**TOWN OF ALGOMA
WINNEBAGO COUNTY, WISCONSIN
PLANNING COMMISSION MEETING
15 N. Oakwood Road, Oshkosh, WI 54904
Wednesday, February 12, 2025 at 6:00 pm.**

RE: **ITEM 4: Discussion and Possible Action re:** Site Plan by petitioner Brandon Robaidek, Robert E. Lee & Associates, Inc on behalf of OSMS Real Estate for an OSMS facility at 200 S. Oakwood Road, Oshkosh, 54904.

OSMS Site Plan Staff Review:

1 TRASH ENCLOSURE PLAN
 1/2" = 1'-0"

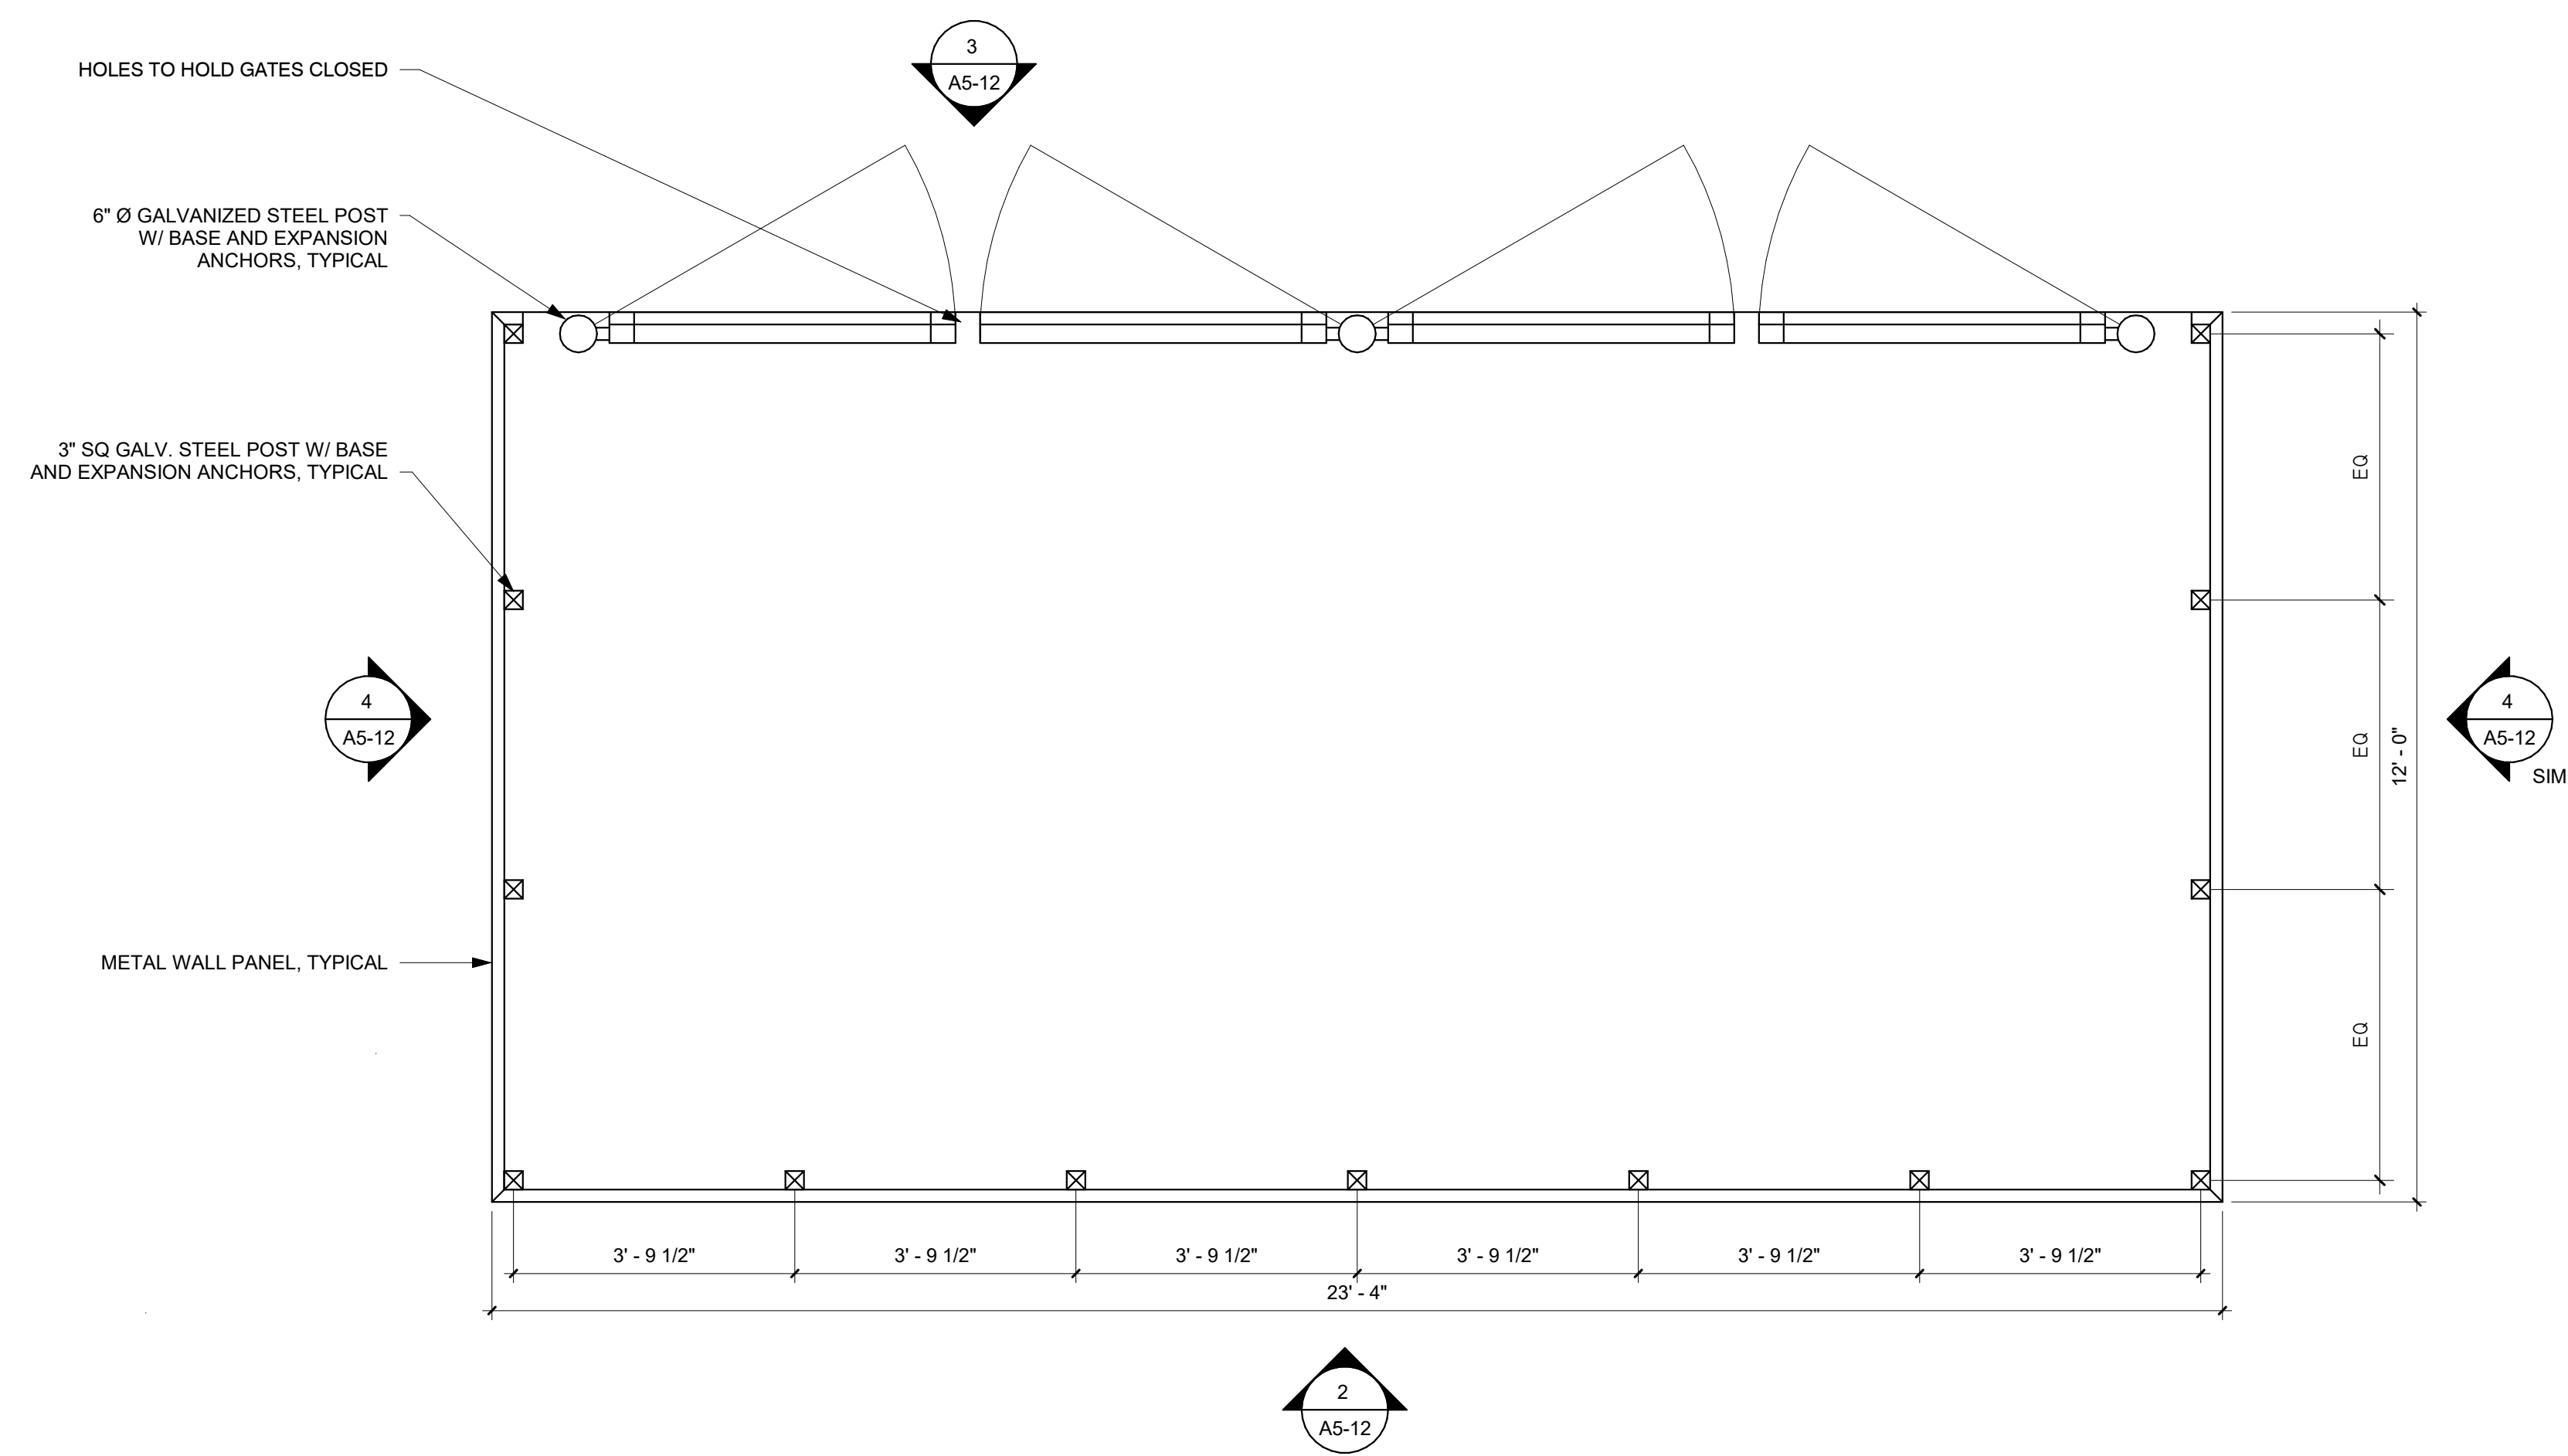
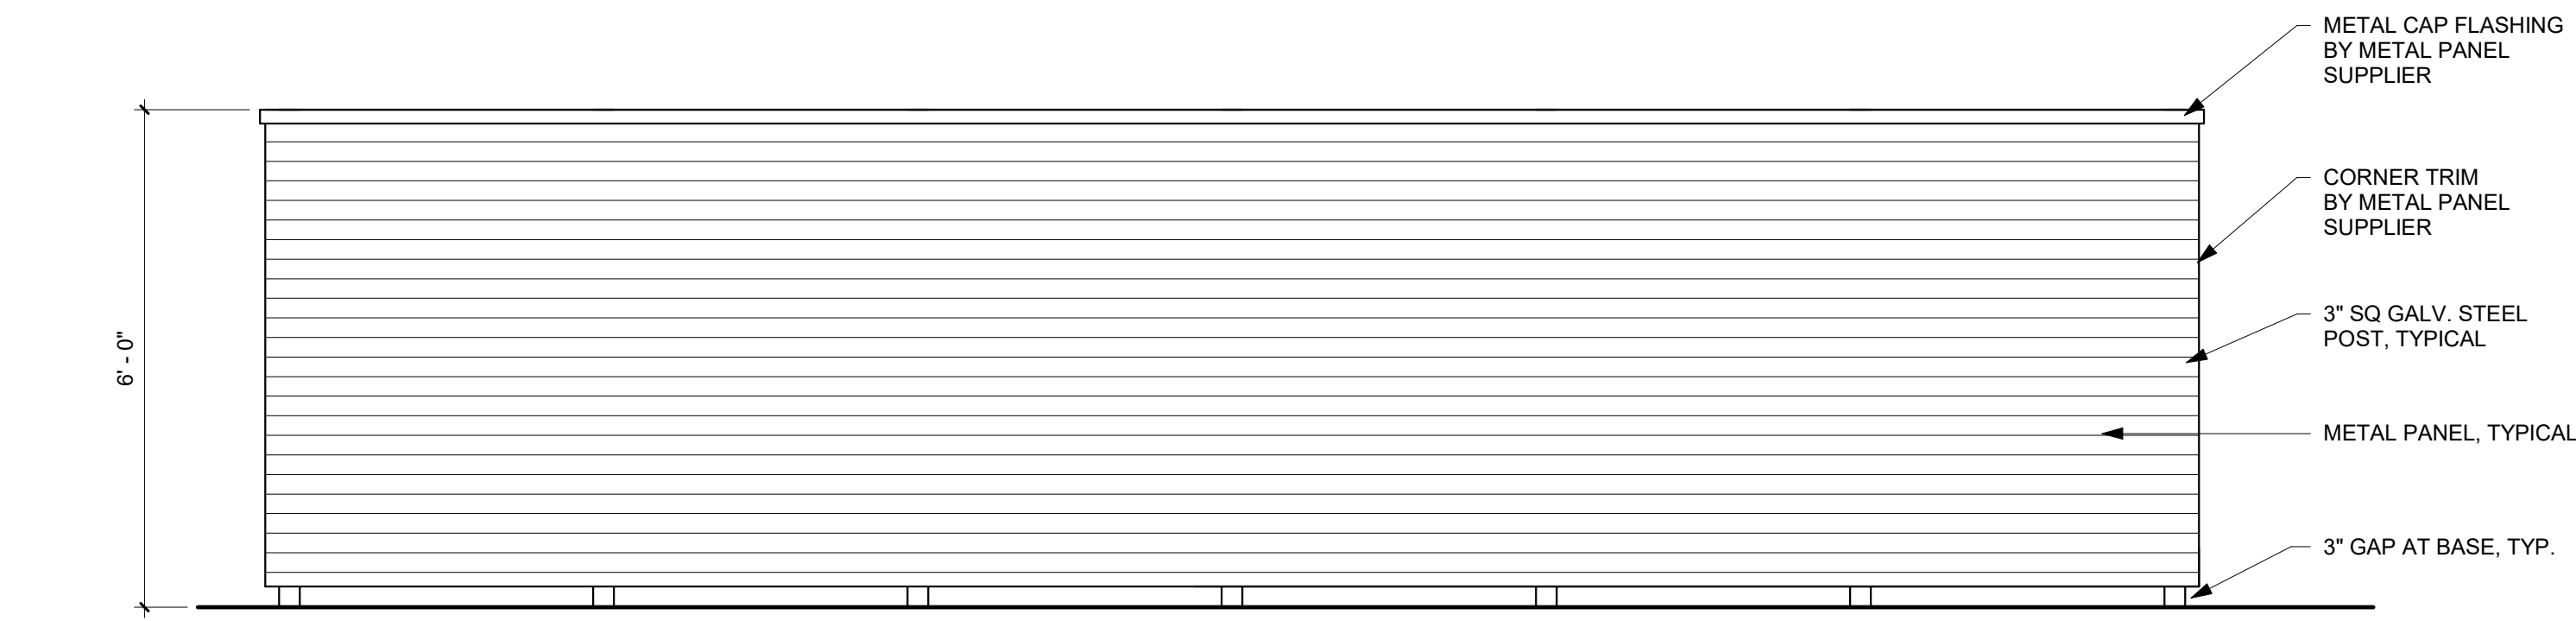
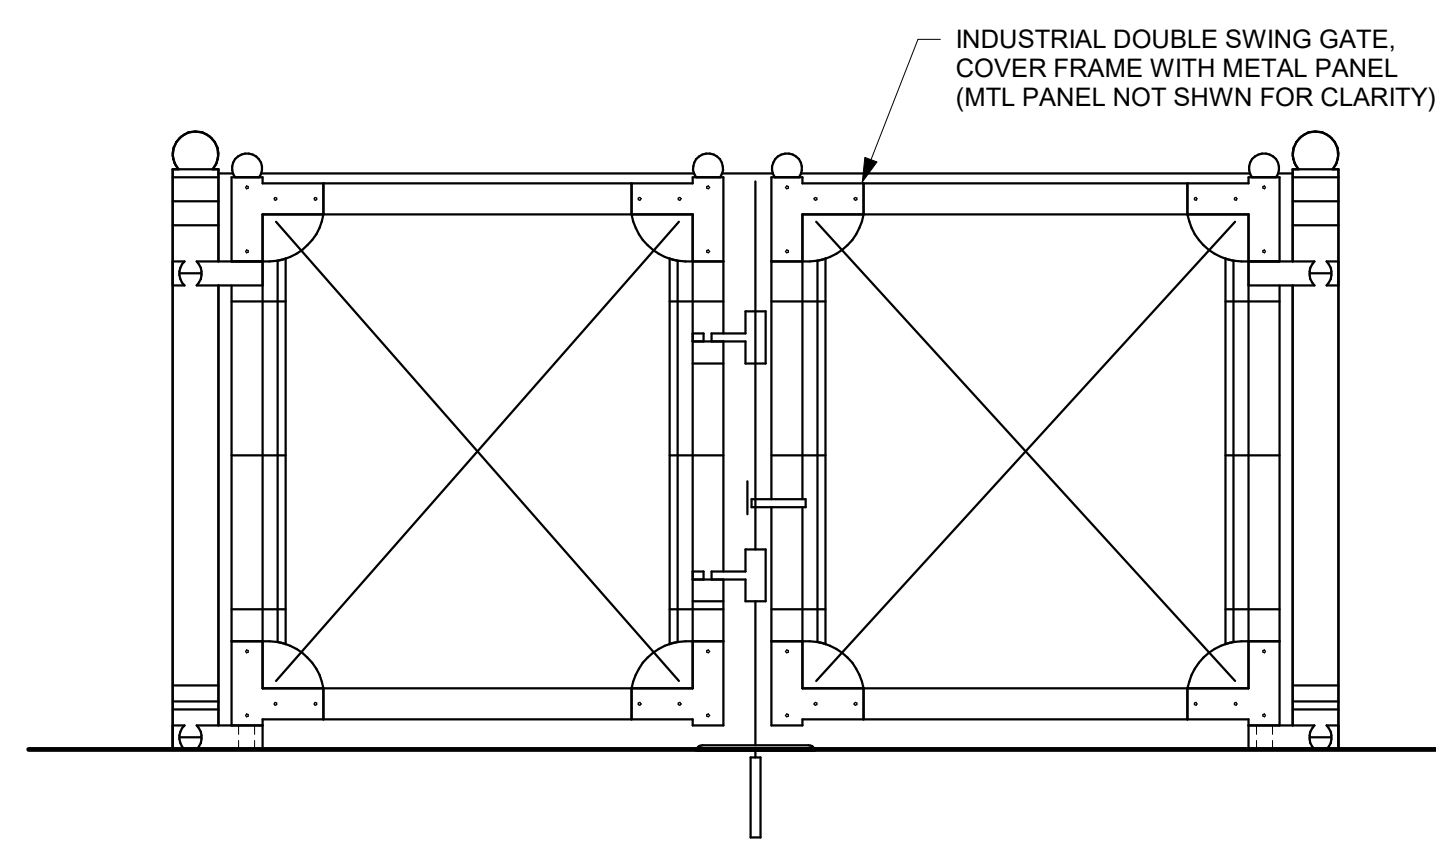
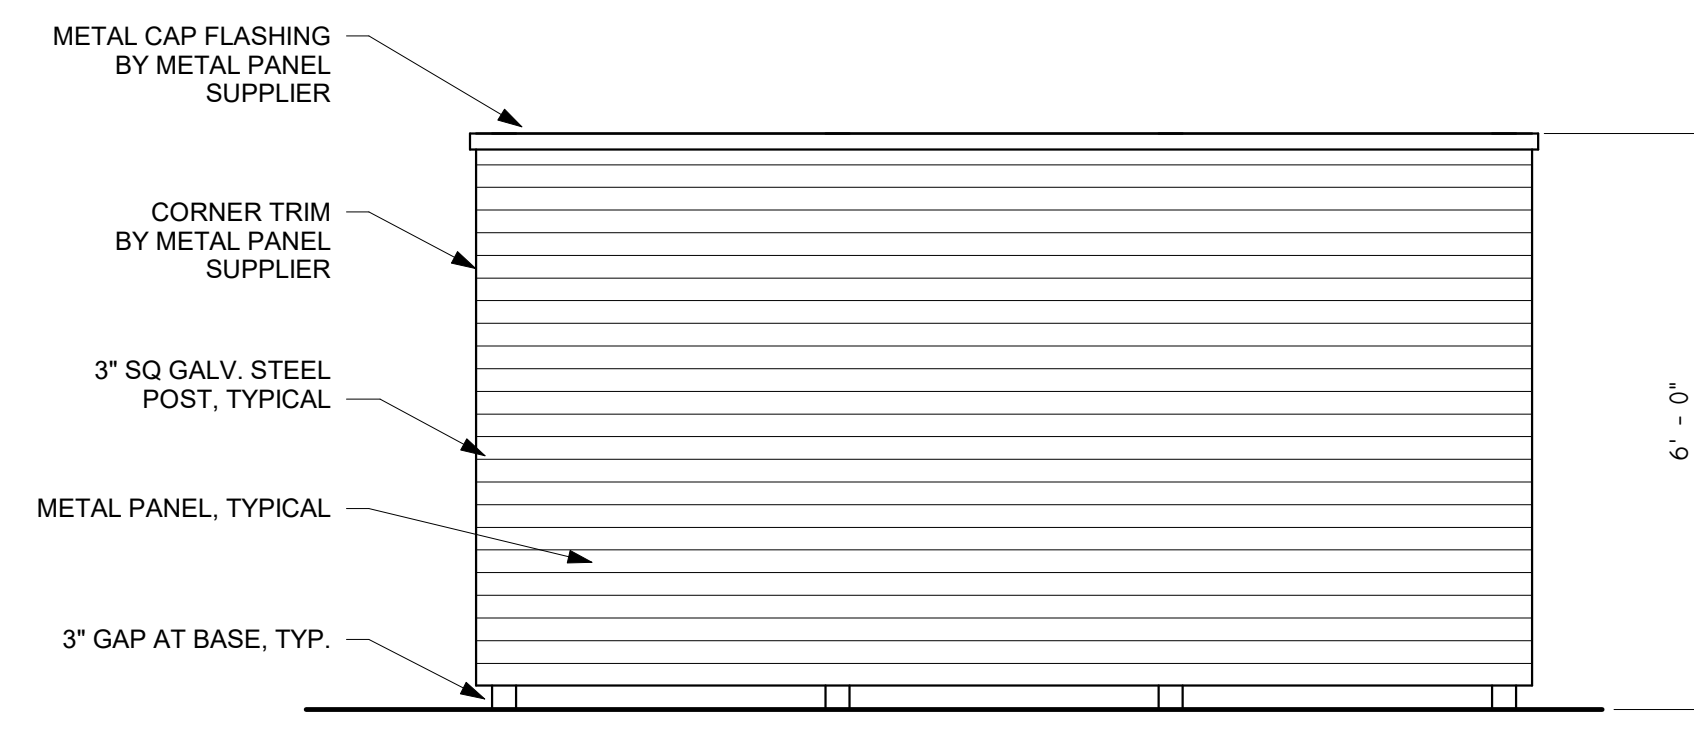
- a. General requirement. Storage of waste or trash shall be kept in an enclosure as described in this section.
- b. Construction standards. An enclosure shall consist of a masonry or solid wooden fence at least six feet in height, with a door having a one-foot vertical clearance at the bottom and a feature that allows doors to be latched in the open position. The floor of a screened enclosure should be at the same level as the lot and be hard surfaced. **Met, enclosure specifications added to plans.**
